Analysis of Removal Alternatives for the Heavy Water Components Test Reactor at the Savannah River Site

Analysis of Removal Alternatives for the Heavy Water Components Test Reactor at the Savannah River Site

April 1997

In December of 1996, public comments on the study were received from nine individuals. Revision 1 includes changes made in response to those comments, which did not change the preferred alternative of dismantlement.

Figure 1. The HWCTR Facility

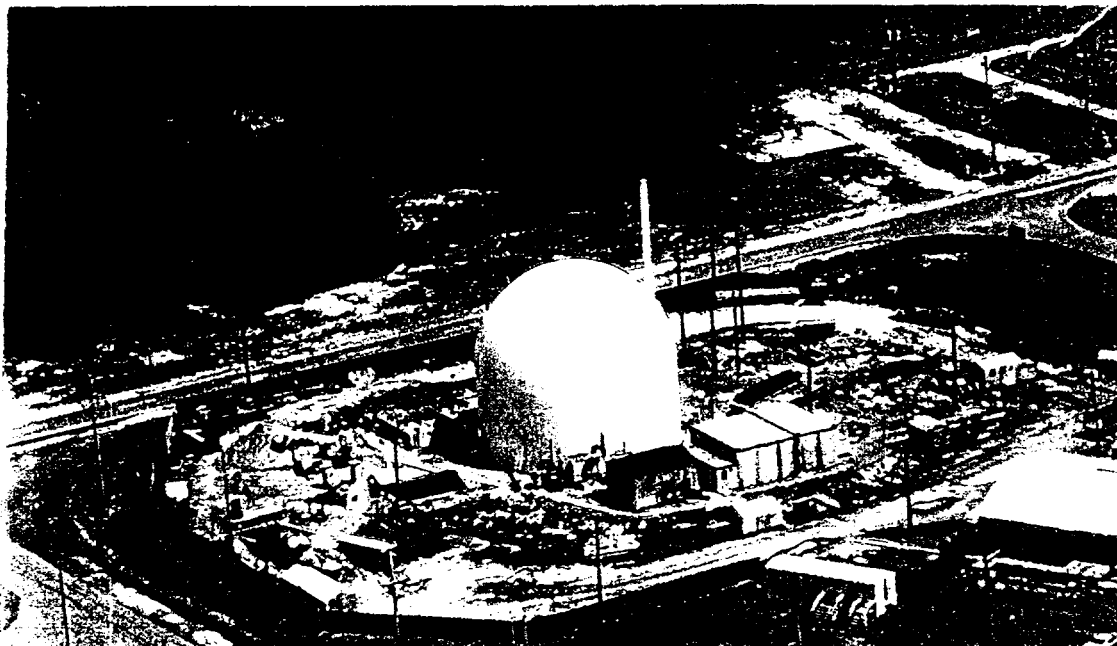
6. Below figure 1 it says the details of the containment building are shown in figures 4 through 27. Actually, considerably more than just the building details are shown; much of the contents of the building are shown. | R3

To improve the accuracy and quality of this study, your comment was incorporated and the applicable section(s) changed. Figures 4 through 27 in Appendix A contain details of the reactor plant as well.

Figure 2. Location of the HWCTR on the Savannah River Site. The HWCTR property, shown in the lower part of the inset, comprises U-Area. U-Area lies within B-Area, which is designated an administrative area in long-term site property plans.

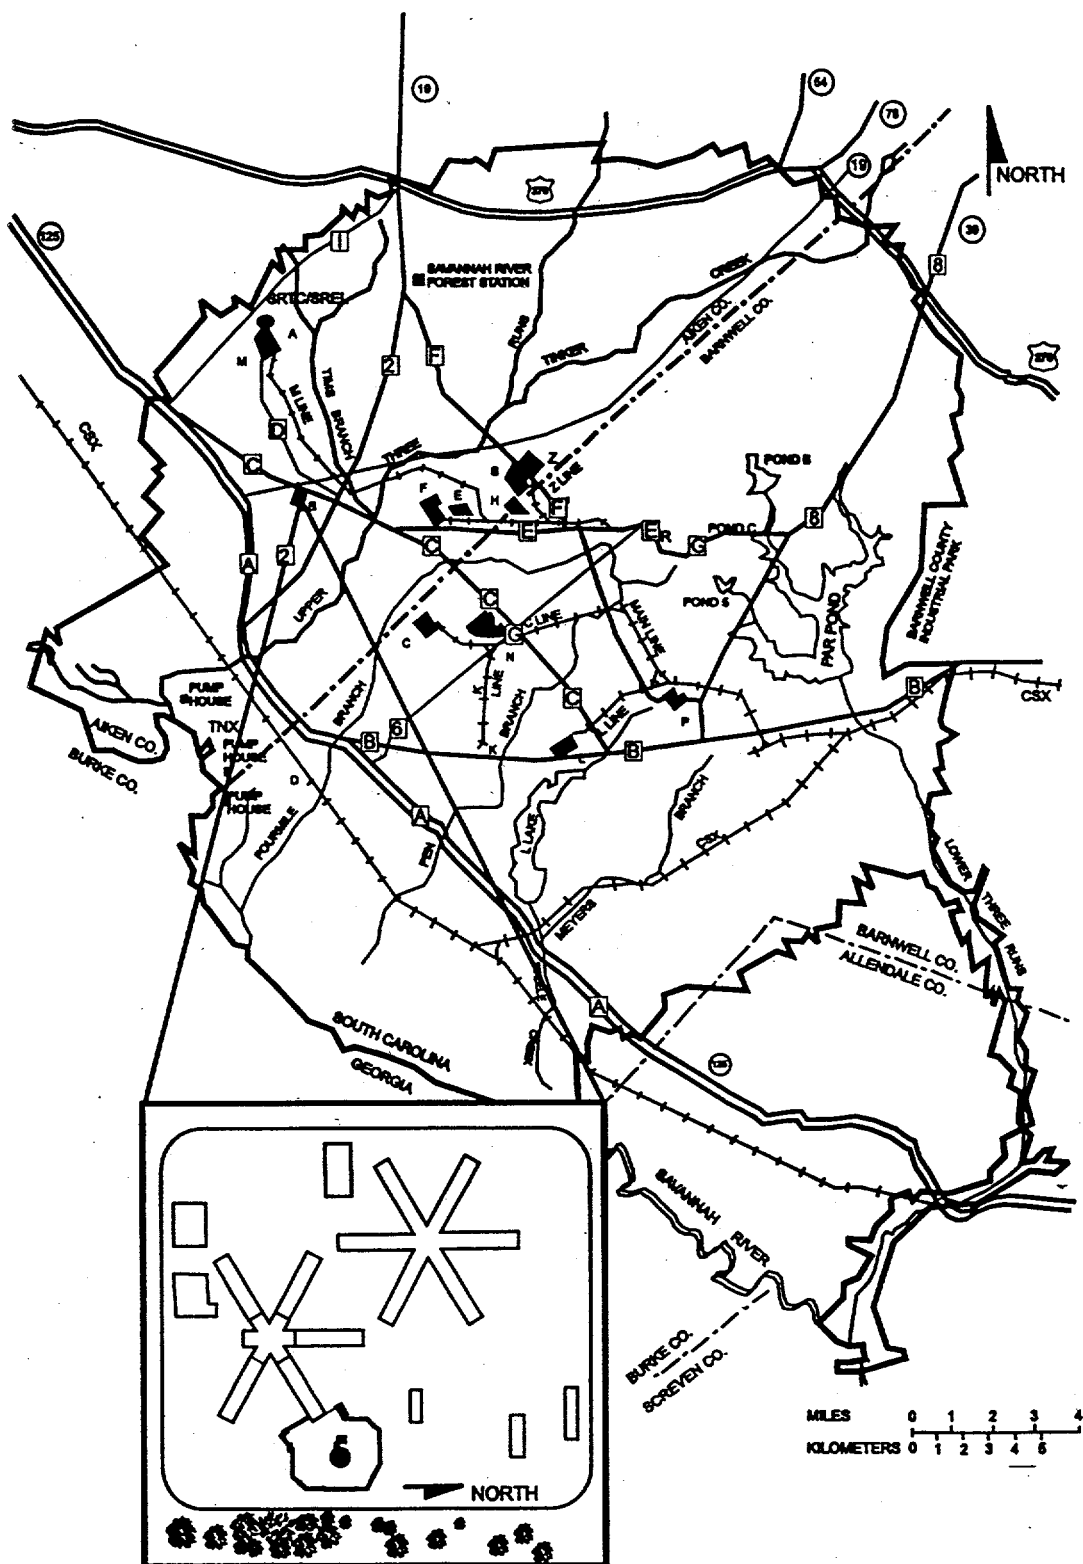
5. On page 6, figure 2 (actually in appendix A) would have been much more helpful had the SRS roads been shown. The map only showed streams, but most persons familiar with the site relate much better to roads. | R3

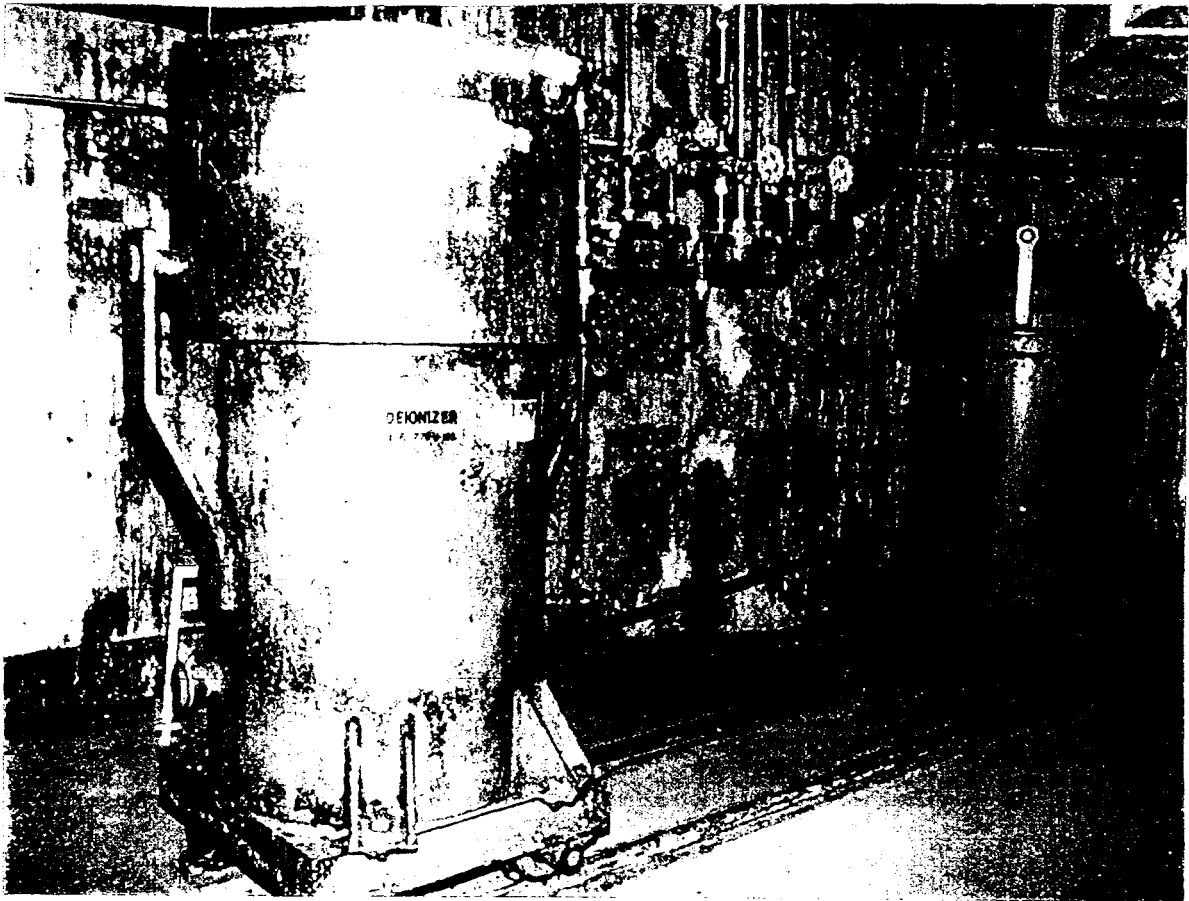
27. On page A10, figure 15, some lead shielded casks are shown. They probably are contaminated but that should be only on the carbon steel structure of the cask. The carbon steel should protect the lead against contact with the radioactivity. So they may be mixed waste only if they are not disassembled into their constituent materials. If that is done, the contaminated steel can be handled as LLW and the lead can be recycled for an economic gain. There are probably more than 100 tons of lead in HWCTR which represents some economic asset in today's "recycle-reuse" environment. R3-27

Figure 21. Construction Photograph Showing Reactor Vessel Outside of Building. On July 3, 1961, the vessel is positioned for movement into the containment building.

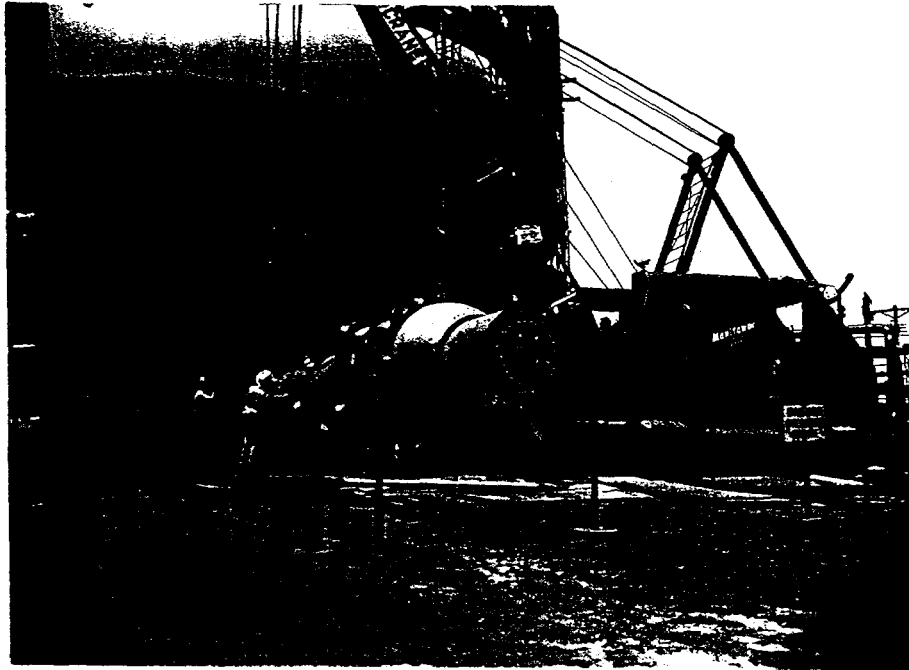
28. On page A13, figure 21, the vessel was moved into the building in 1961, not 1959. This photograph was taken on July 3, 1961. R3-28
29. On page A13, figure 22, the opening cut in the containment dome was cut on the south side of 770-U near the spent fuel basin. The equipment hatch is on the east side of 770-U. It was not used for reactor installation. But it was used for installation of most all other large equipment. Perhaps only the polar crane came in through the large hole. A larger hole than the 7' x 7' equipment hatch to permit dismantlement of HWCTR may not be necessary. R3-29

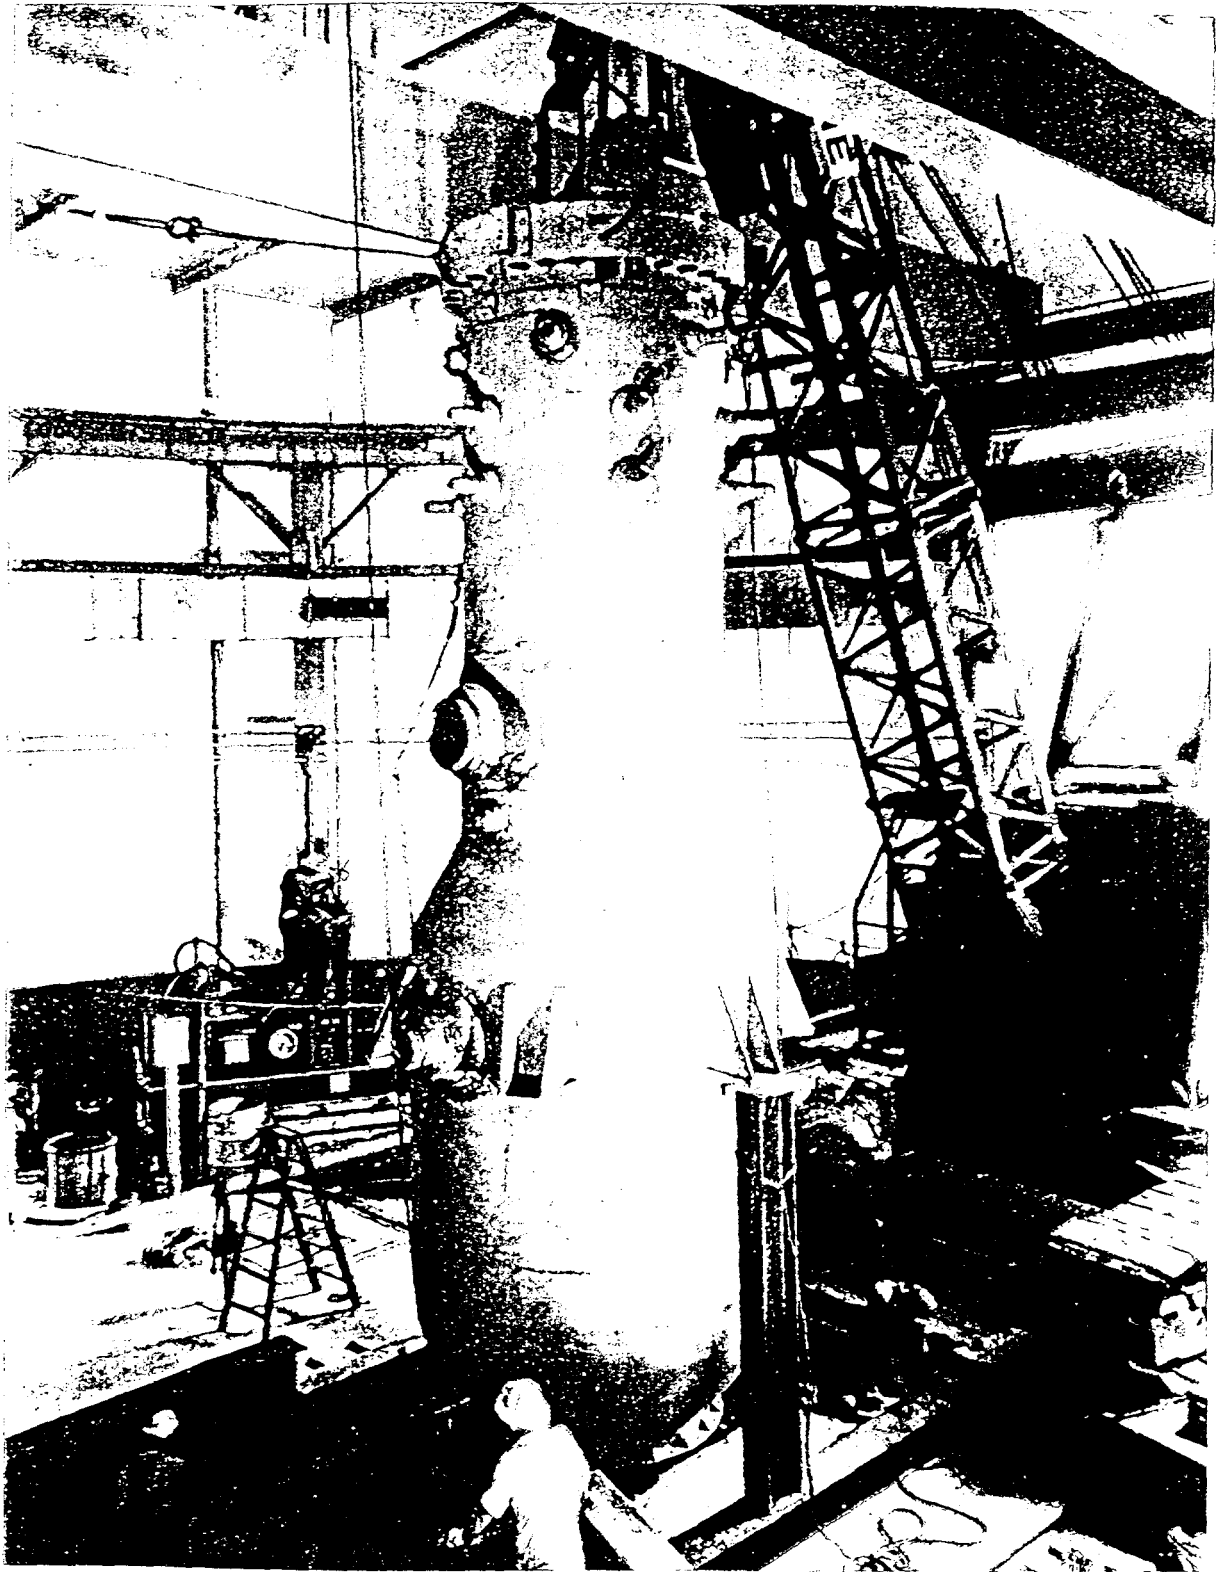
30. On page A14, figure 23, the vessel shell contains 25 nozzles, not 24. R3-30
31. On page A16, figure 27, the vessel head is not installed. The head is suspended from the rod drive platform but the platform is not over the reactor; it has been moved aside to the position it occupied during fuel charge-discharge. R3-31
